PRODUCT CHANGE NOTIFICATION

PRODUCT CHANGE NOTIFICATION NUMBER: PC12587

PCN DATE: Sept. 30, 2025

Strain relief boots with cable opening diameters of 0.224 inch and 0.24 inch.

Appendix A

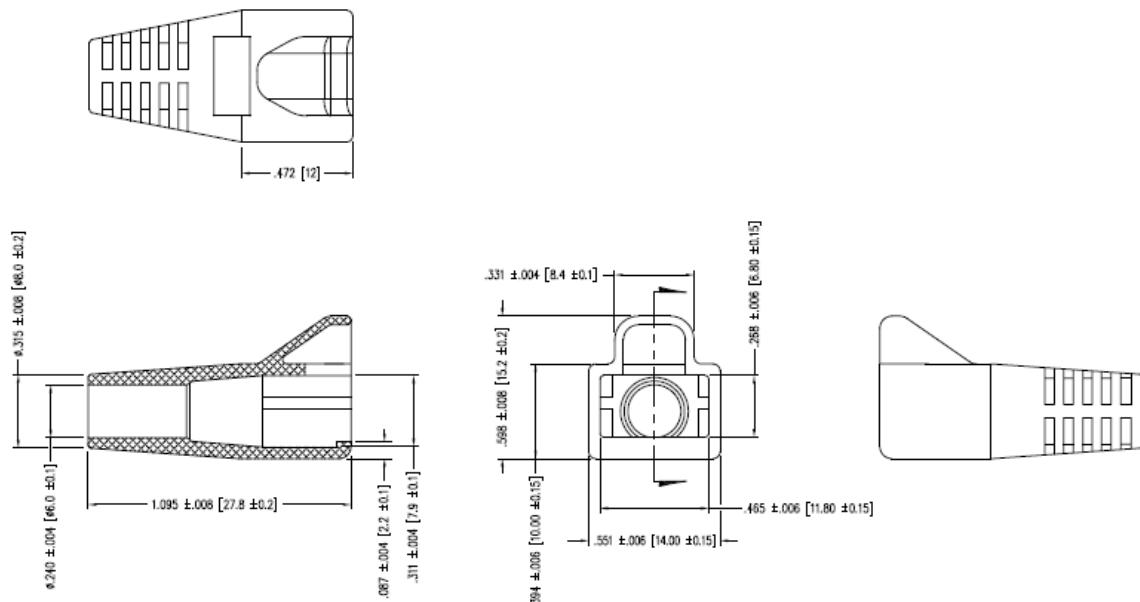
| Obsolete Part Numbers | Replacement Part Numbers | New Part Drawing Numbers | Noteable Differences |
|---|--------------------------|--------------------------|--|
| 450-011 through 450-018 For Boot diam 0.224" | Same | CT999002 Rev D0 | Slightly smaller size and shape of anti-snag feature, No Stewart logo. |
| 450-023 through 450-032, and 450-044 For Boot diam 0.24" | Same | CT999007 Rev C0 | Slightly smaller size and shape of anti-snag feature, Cable exit hole is .27" versus .24" diameter |
